Project name: Webster ISB Phase 1

Drawing No.	Revision No.	Placing drawing description
R01-01	1	Level 0 Found Elevation Plan & Sections
R01-02	0	Level 0 East/West Grade Beam & Wall Elevations
R01-03	0	Level 0 East/West Grade Beam & Wall Elevations

RE: steel reinforcement shop drawings level 00
foundation grade

Subject: 03 3000 Cast-In-Place Concrete –
Steel Reinforcing Shop Drawings –
Level 00 Foundation Grade Beams,
Walls, and Pilasters

LEVEL 0 FOUNDATION ELEVATION PLAN
SCALE: 1/8"=1'-0"

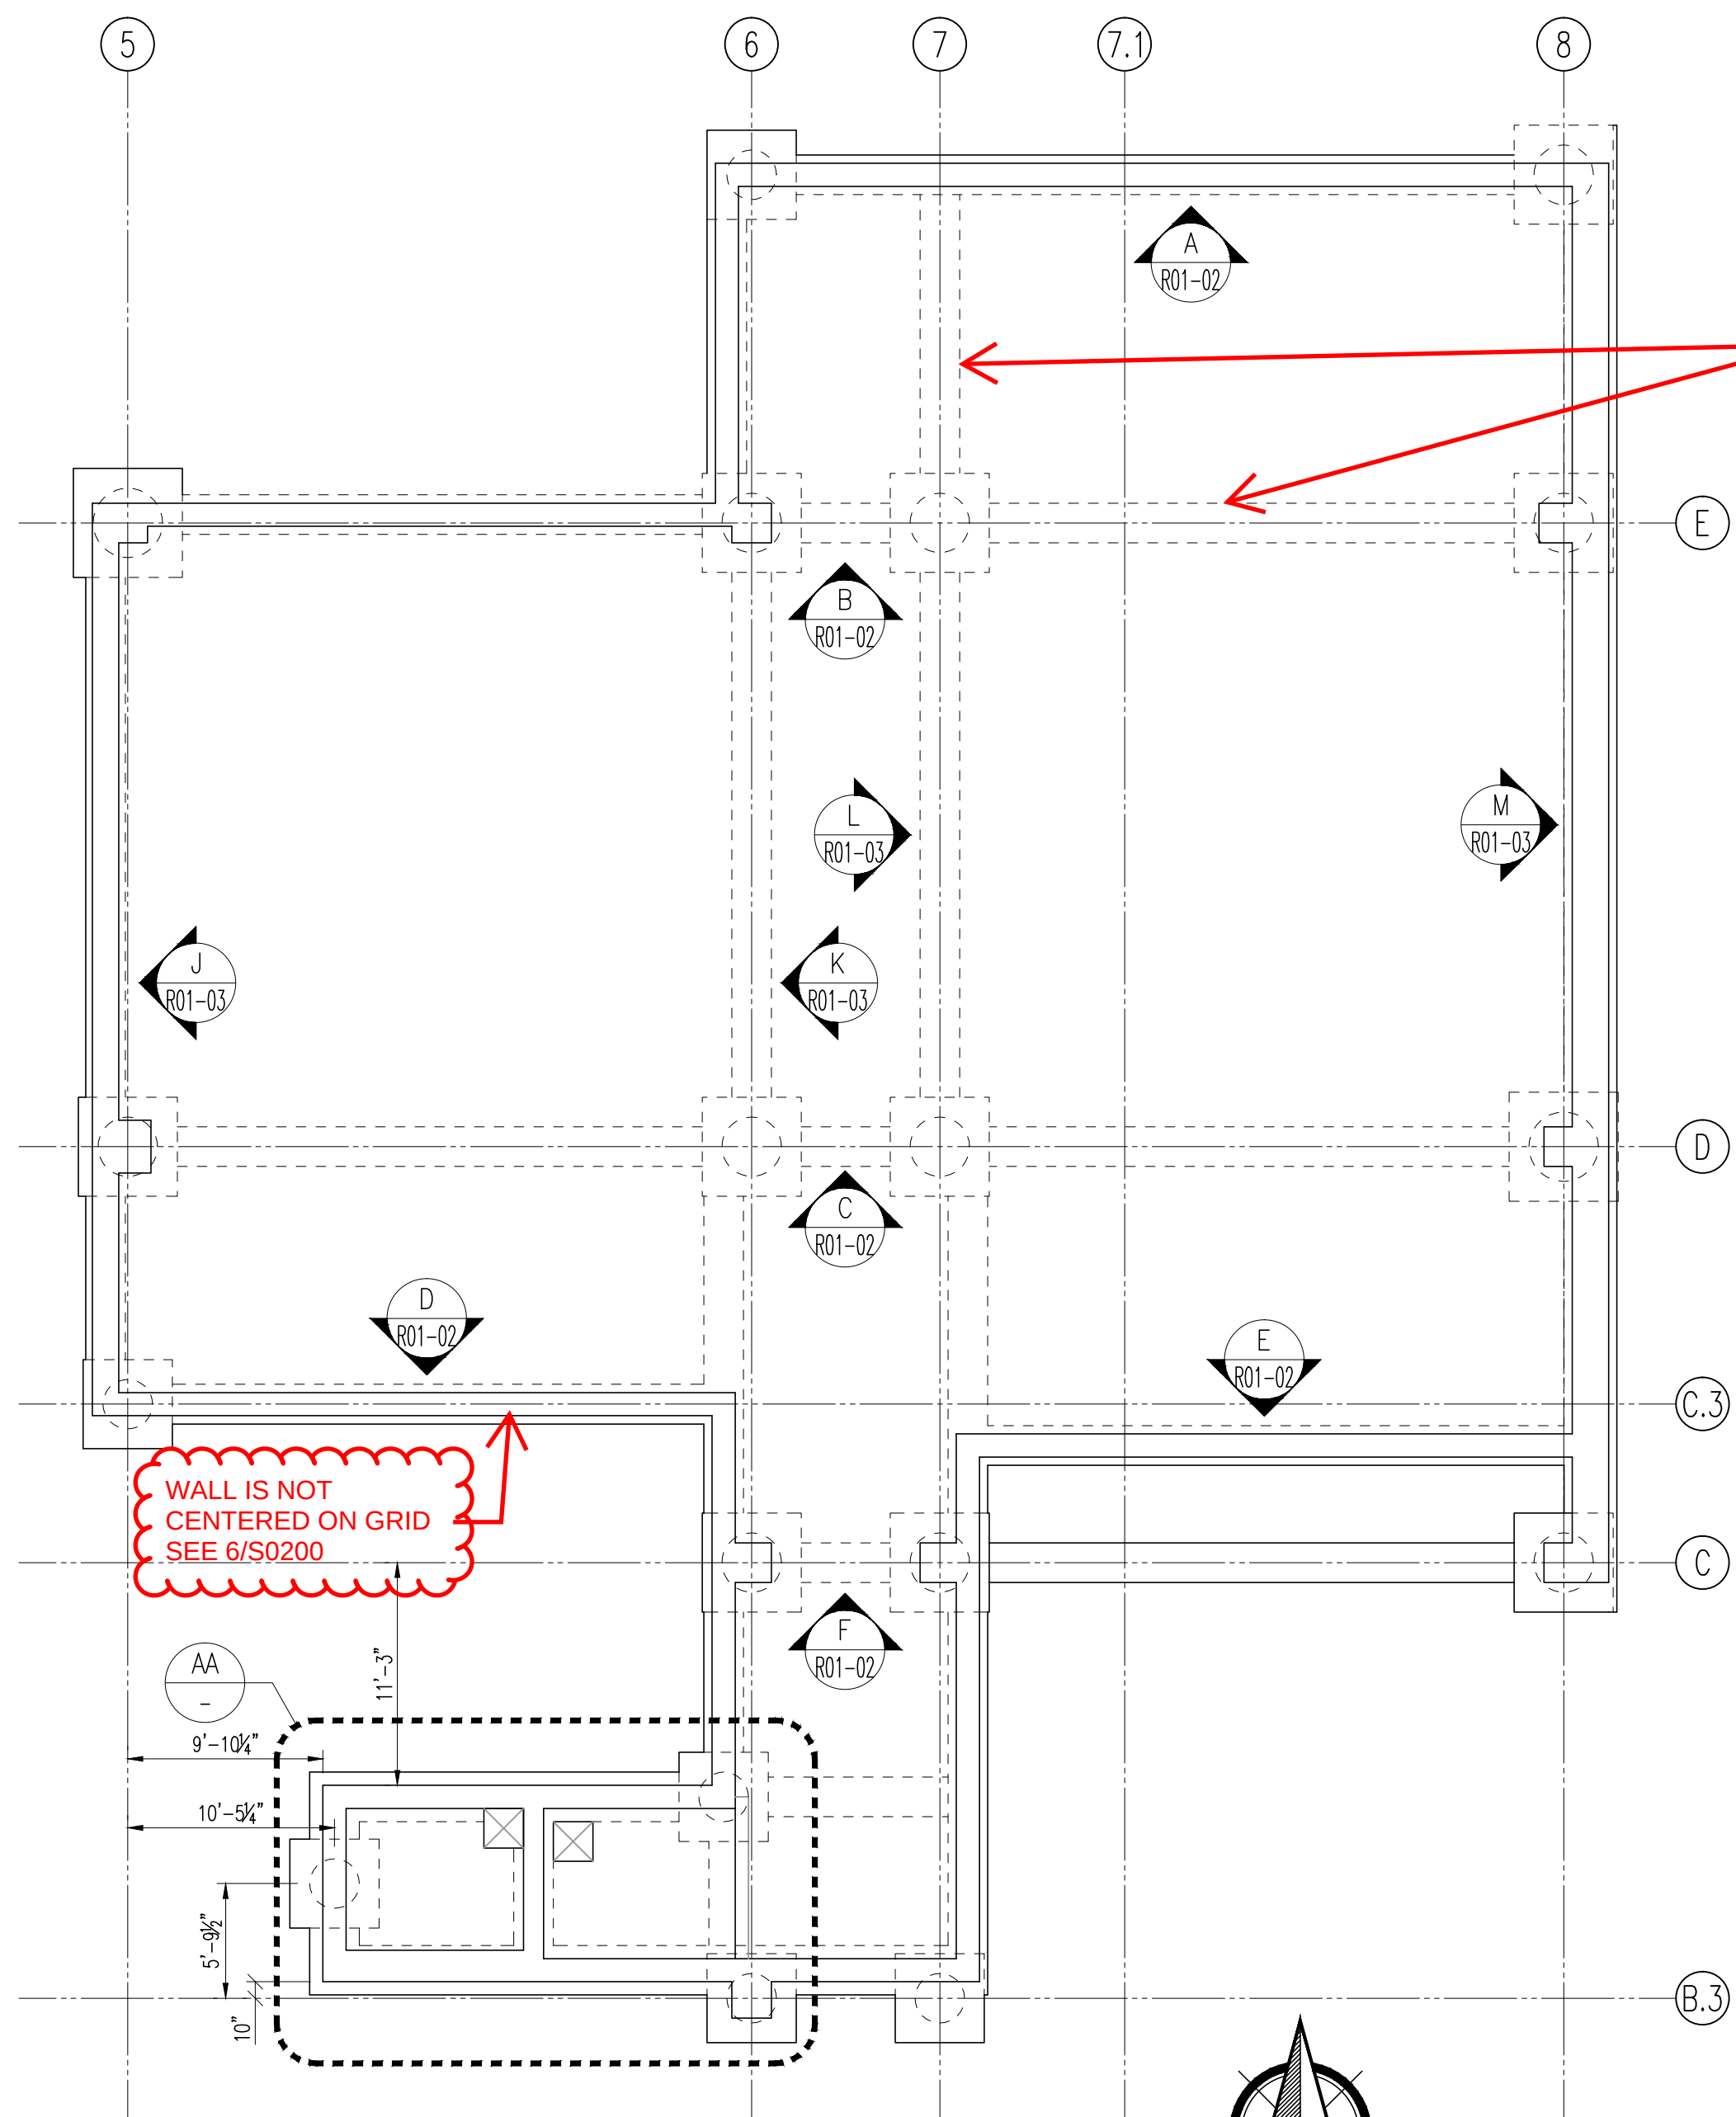
GRADE BEAM PENETRATION
COORD W/PLMG DRAWINGS
AND CONTRACTOR

SUMP PIT SIZE AND
LOCATION TO BE
COORDINATED BY
GC AND ELEVATOR
MANUFACTURER

SEE CLIP OF CURRENT
ELEVATOR PIT & WALLS
ON R01-04

AA DETAIL
SCALE: 1/4"=1'-0"

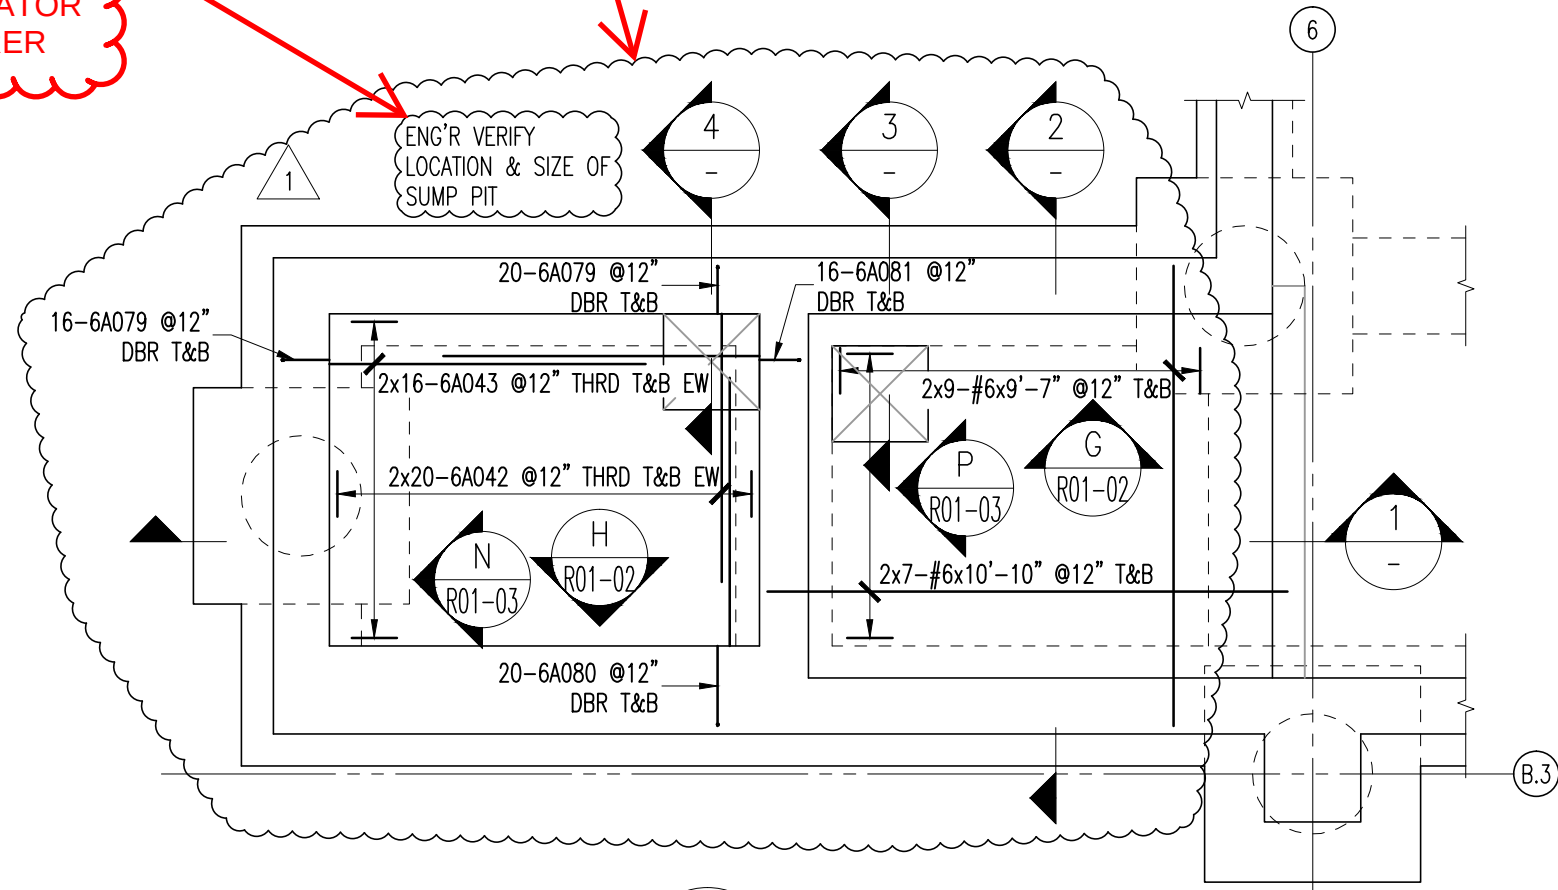
WALL IS NOT
CENTERED ON GRID
SEE 6/S0200

TYPICAL PIPE PENETRATION @ GRADE BEAM

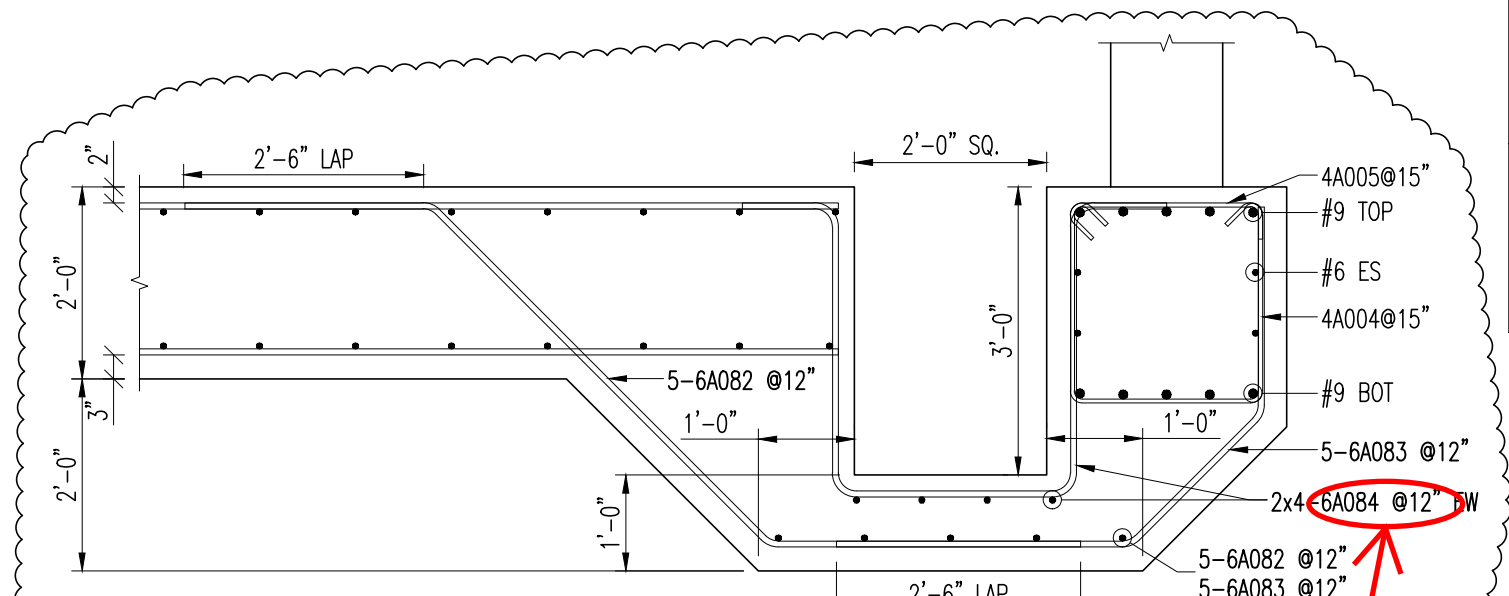
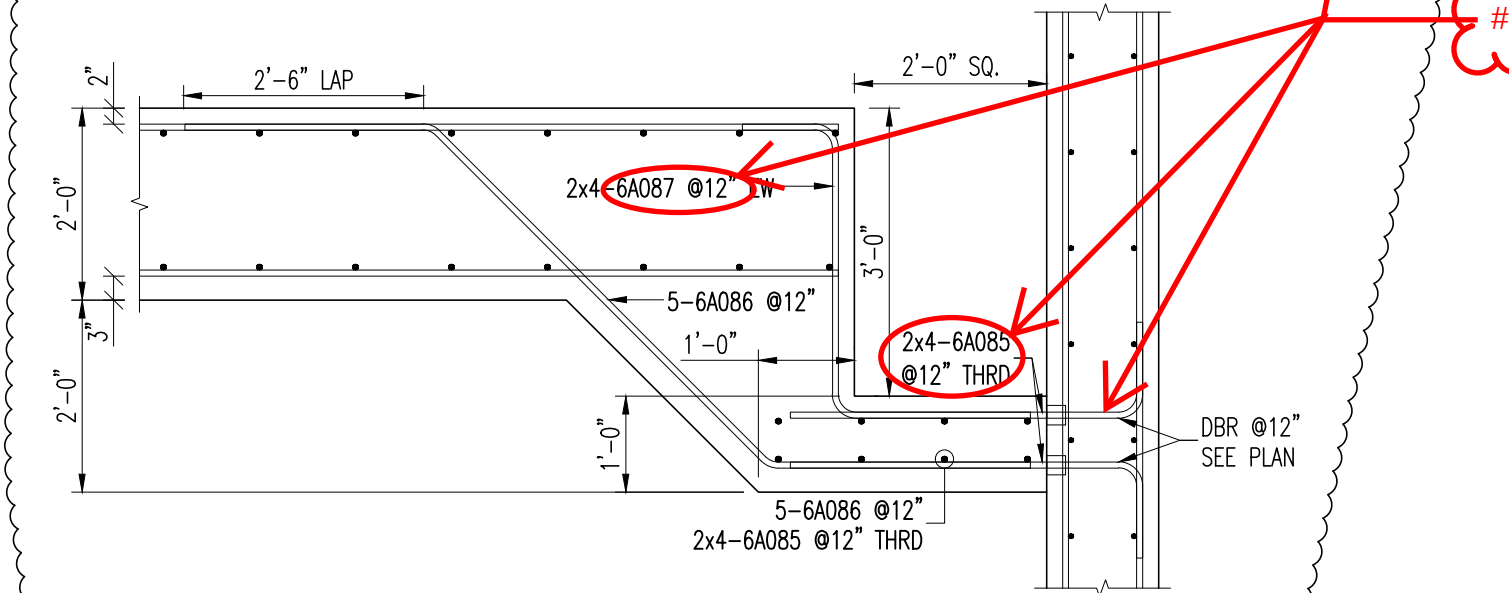
COORD W/PLMG
DWGS AND CONTR

MATCH GRADE
BEAM BOT REIN

1 SECTION
SCALE: 1/2"=1'-0"

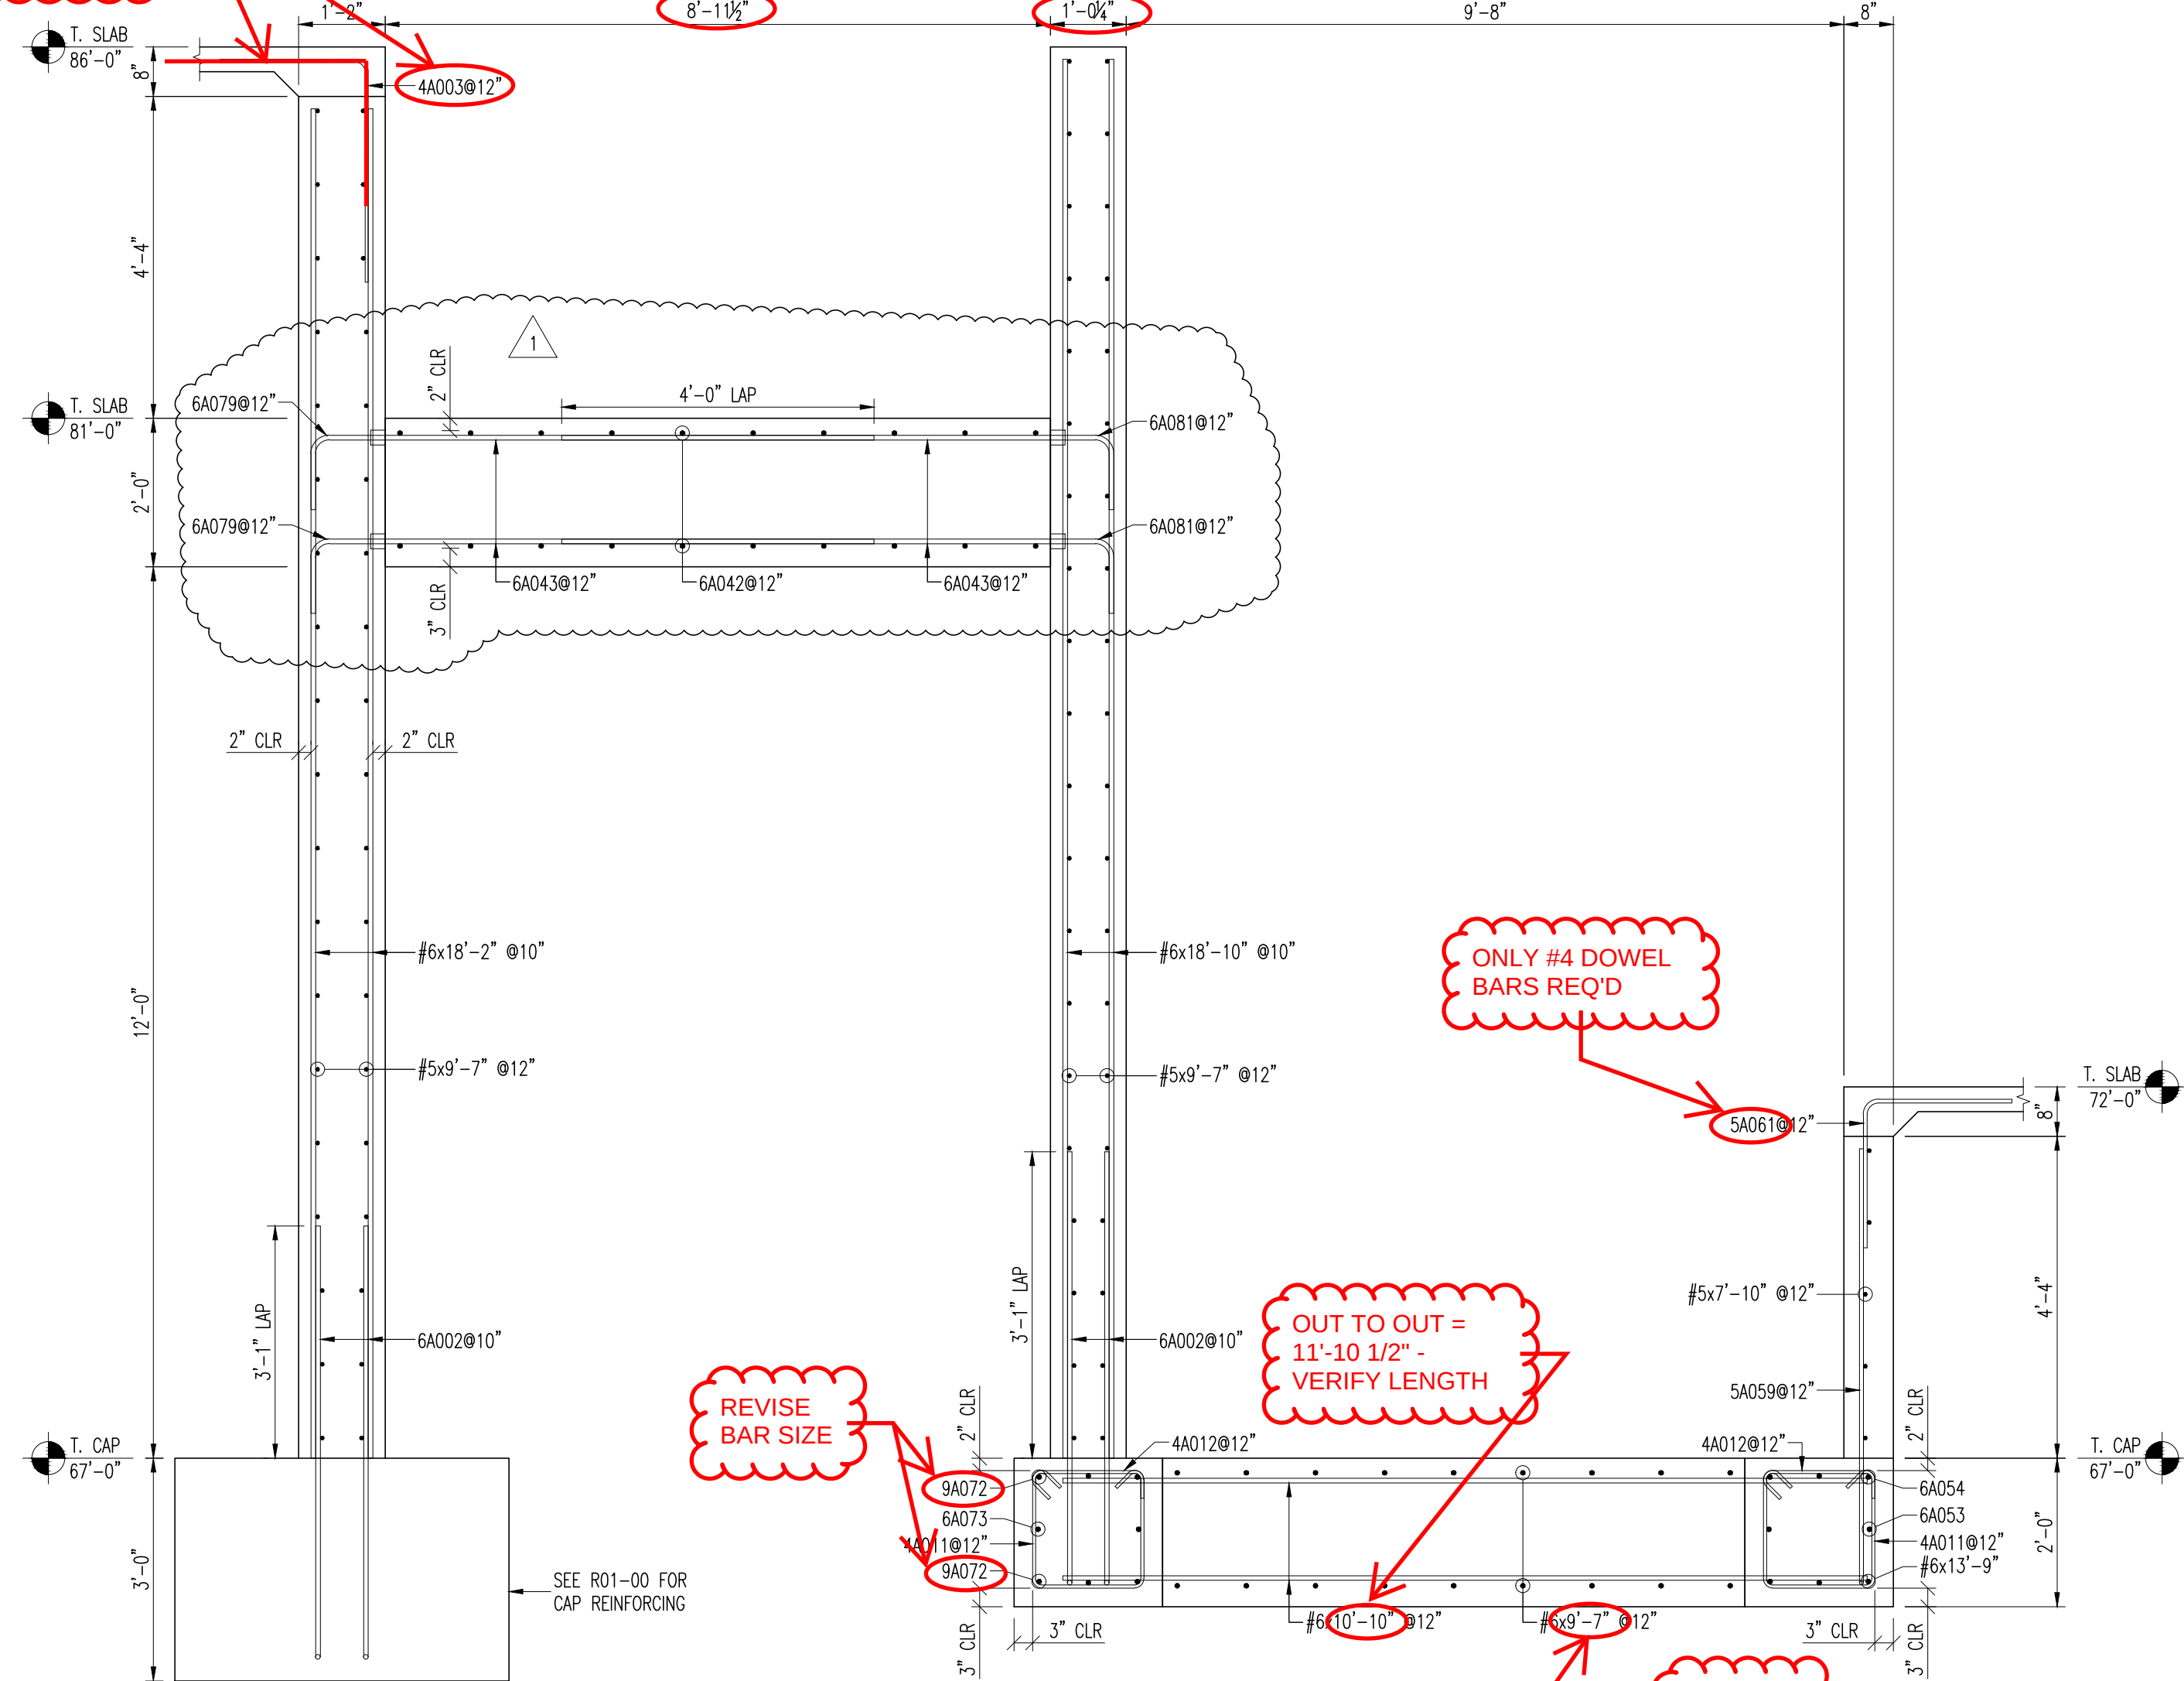
CLARIFICATION:
DOWELS ARE
24" VERT AND 36"
HORIZ - TYPICAL

ONLY #4 DOWEL
BARS REQ'D

OUT TO OUT =
11'-10 1/2"
VERIFY LENGTH

REVISE
BAR SIZE
